Subject: Potential Valve Failures and Corrective  
Action Relating Thereto

SUBJECT:	REPLACEMENT PARTS KIT P/NO:	<u>325649</u>
	KIT P.O. NUMBER:	<u>NQ-10443-B-RD</u>
	ORIGINAL P.O. NUMBER:	<u>NEG-51082</u>
	VALVE TAG NUMBERS:	<u>8685 &amp; 8690</u>
	XOMOX DRAWING NUMBER:	<u>18747-01</u>
	XOMOX SALES ORDER NUMBER:	<u>E-69186</u>

DRIVE ADAPTOR REPLACEMENT INSTRUCTIONS FOR XOMOX-  
MOUNTED LIMITORQUE ELECTRIC MOTOR ACTUATORS MODEL  
H0BC, H1BC, H2BC, H3BC, H4BC, AND H5BC ON TUFLINE PLUG  
VALVES AND PLIAXSEAL HIGH PERFORMANCE BUTTERFLY VALVES

FIGURE 3

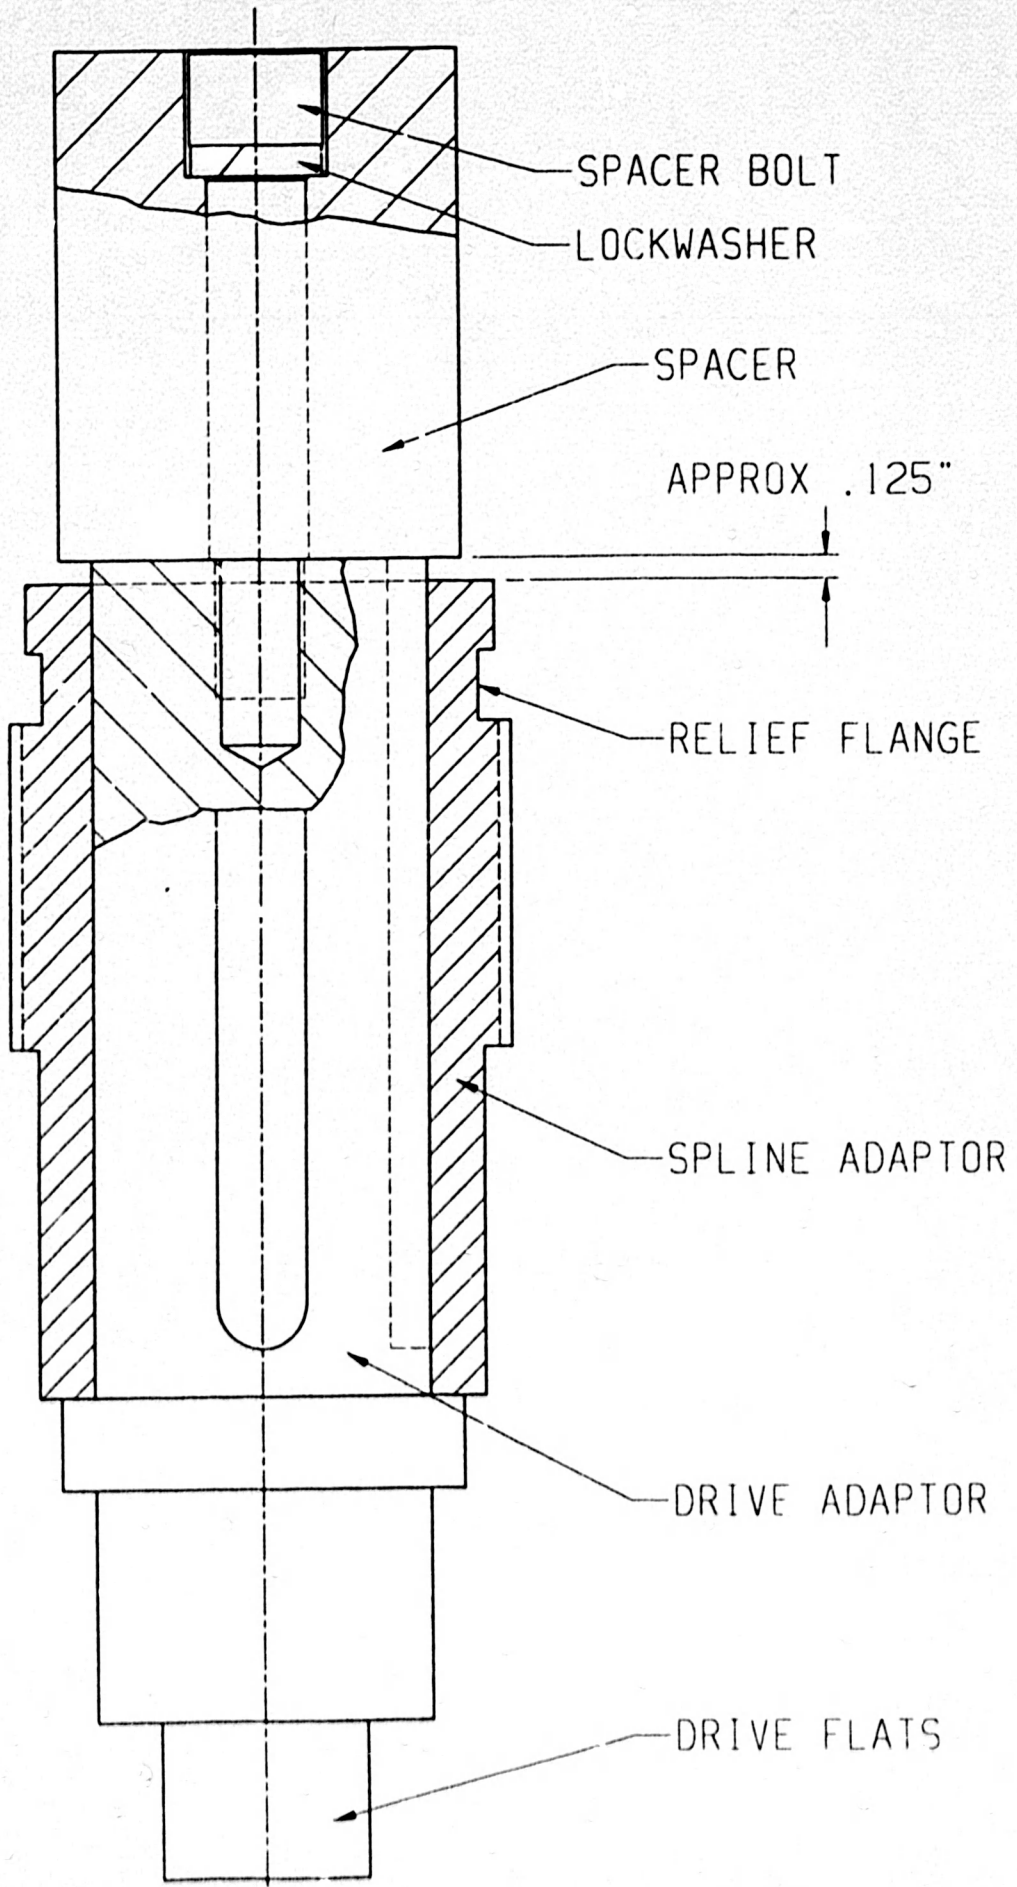
5.2.3 Holding the spline adaptor with its relief flange to the right, insert the new drive adaptor with the new key into the spline adaptor from the left with the drive flats to the left, engaging the key in one of the slots in the spline adaptor. See Figure 3.

5.2.6 Fasten the spacer and spacer bolt to the right end of the new drive adaptor, tightening the spacer bolt down with an Allen wrench to a torque of 40-50 ft.-lbs. See Figure 3.

**FIGURE 4**

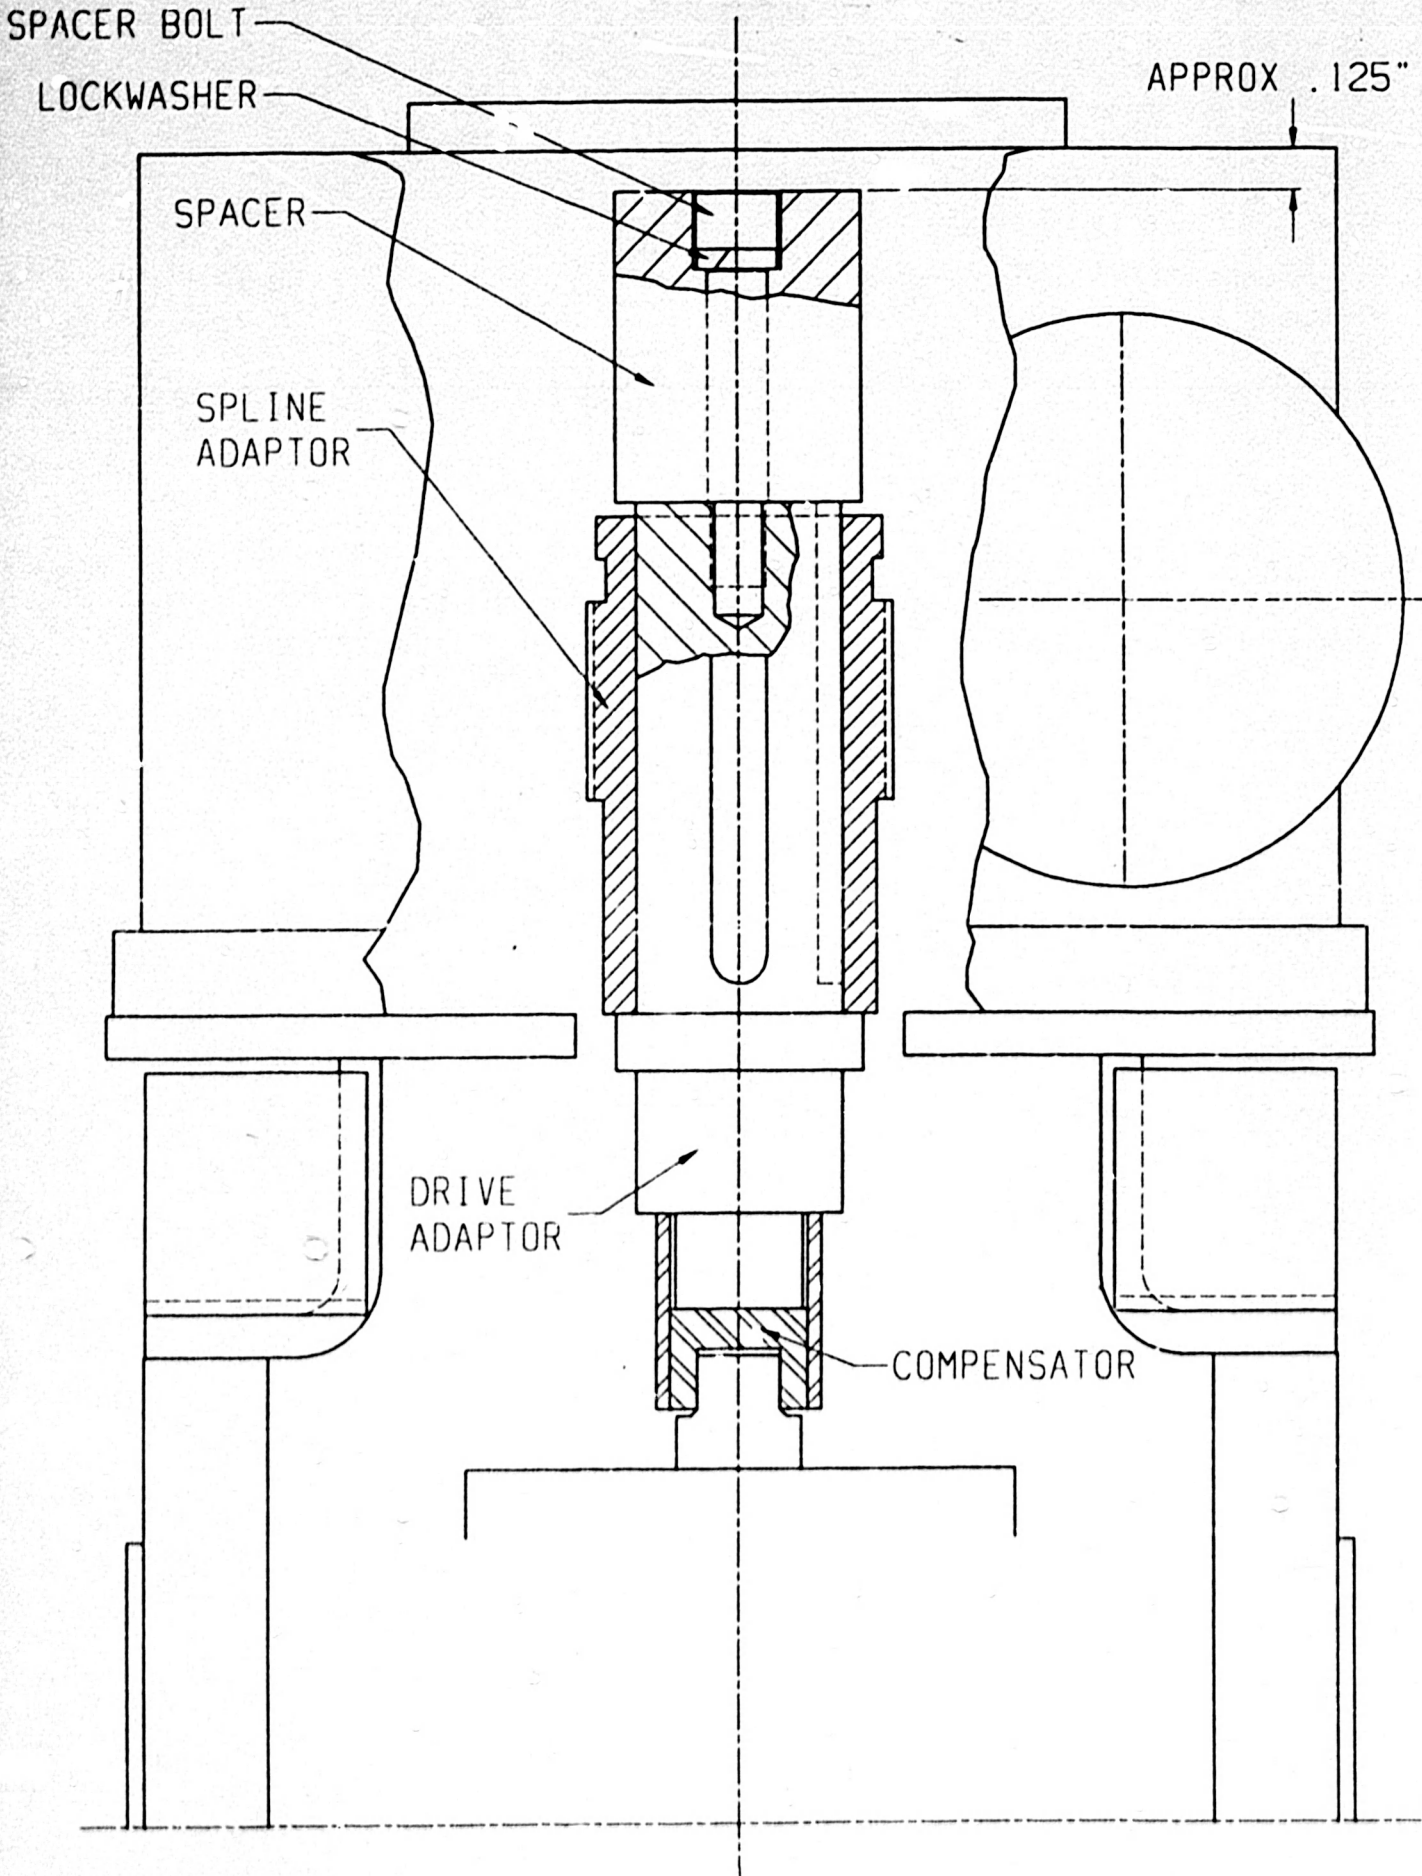
- 5.2.11 Engage the drive adaptor assembly flats fully into the compensator (or, where the compensator is fabricated as an integral part of the drive adaptor, fully engaged on the valve stem). See Figure 4.

FIGURE 5

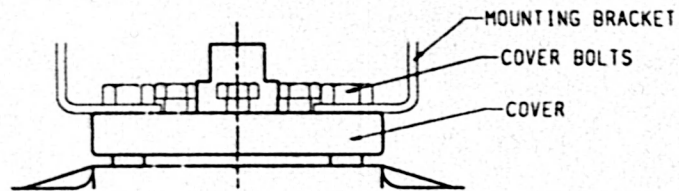
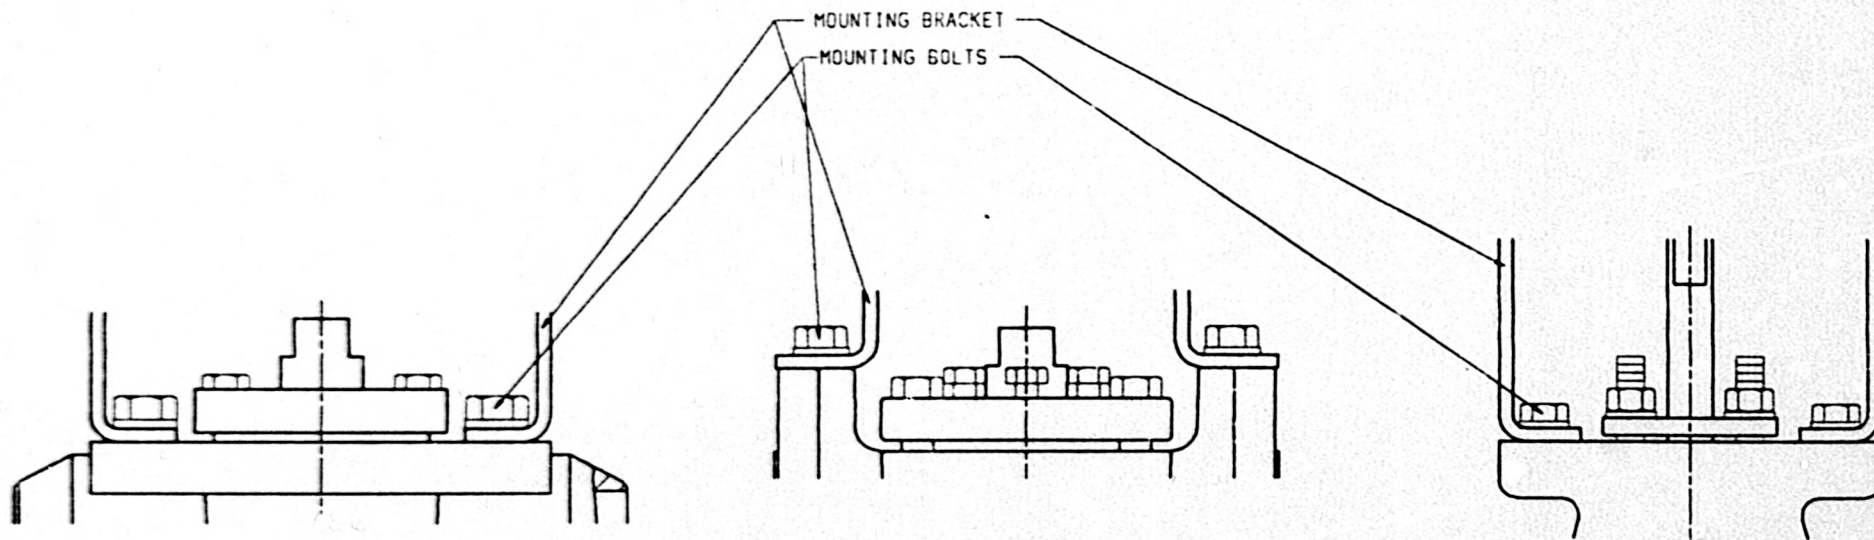
**WARNING:** IF THE BRACKET IS BOLTED DIRECTLY TO THE VALVE COVER (SEE FIGURE 5), DO NOT UNBOLT THE MOUNTING BRACKET FROM THE VALVE IN ORDER TO REMOVE THE ACTUATOR. IN A PLUG VALVE, THE VALVE COVER AND/OR PLUG MAY BE SUBJECTED TO ENTRAPPED PRESSURE DESPITE ANY DEPRESSURIZATION OF THE LINE SO THAT IMPROPER PROCEDURE IN UNBOLTING THE VALVE COVER COULD ALLOW THE PLUG AND/OR COVER TO EJECT SUDDENLY FROM THE VALVE AND CAUSE PERSONAL INJURY OR PROPERTY DAMAGE. IN SUCH CIRCUMSTANCES, LEAVE THE MOUNTING BRACKET IN PLACE AND REMOVE THE ACTUATOR BY UNBOLTING IT FROM THE BRACKET.

IF THE BRACKET IS NOT BOLTED DIRECTLY TO THE VALVE COVER (I.E., IT IS MOUNTED TO THE VALVE FLANGE OR TO SOME OTHER MOUNTING PAD (SEE FIGURE 5), THEN THE BRACKET MAY BE UNBOLTED FROM THE VALVE IN ORDER TO REMOVE THE ACTUATOR.
